March 4, 2012

I have read Michele Edl's February 3, 2012 memorandum regarding review of the beneficial use field report for permit 63-12593. Below are quoted sentences from that review memo followed by my response comments.

Schematic of Idanha Building Heating and Cooling System
Permit 63-12593 (not to scale)

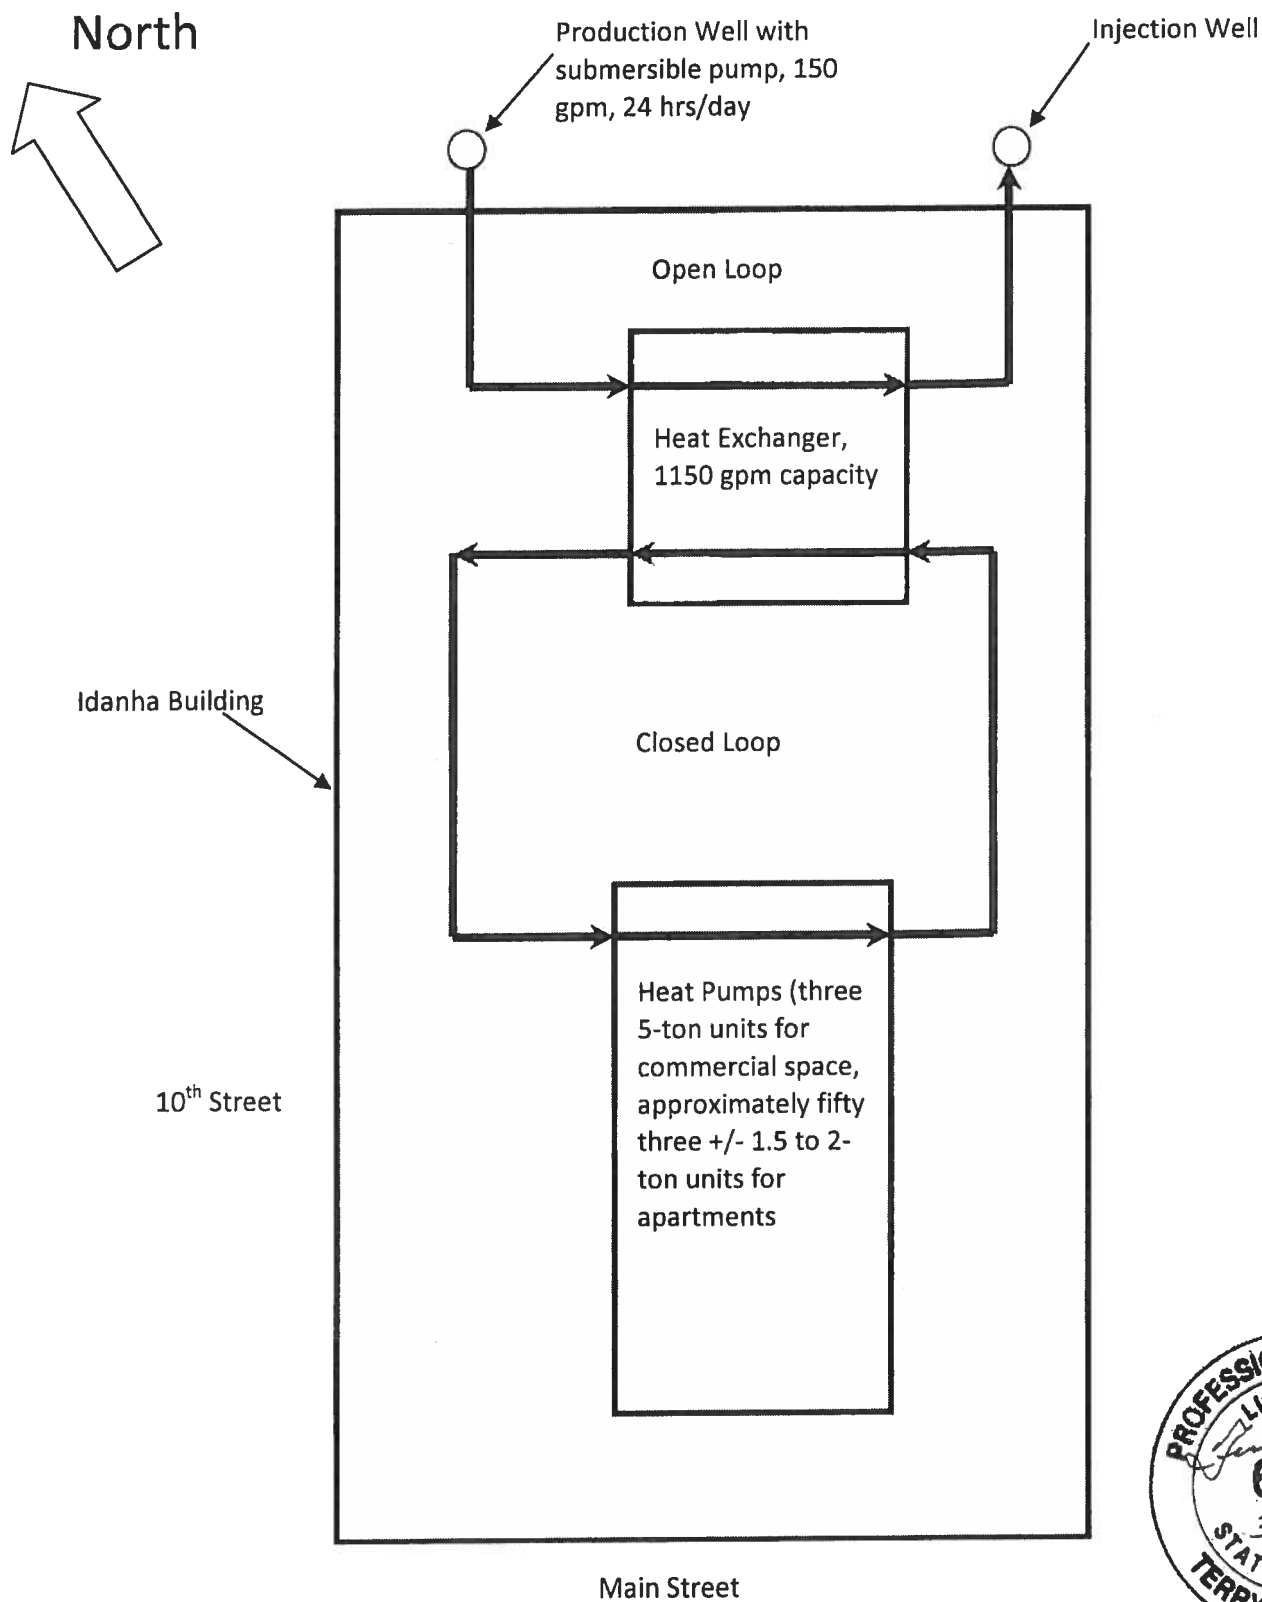
13. *The system description provided in the narrative is both lacking in detail and outside the most relevant timeframe. A detailed schematic and/or as-built drawings of the system are needed.*

Attached is a schematic.
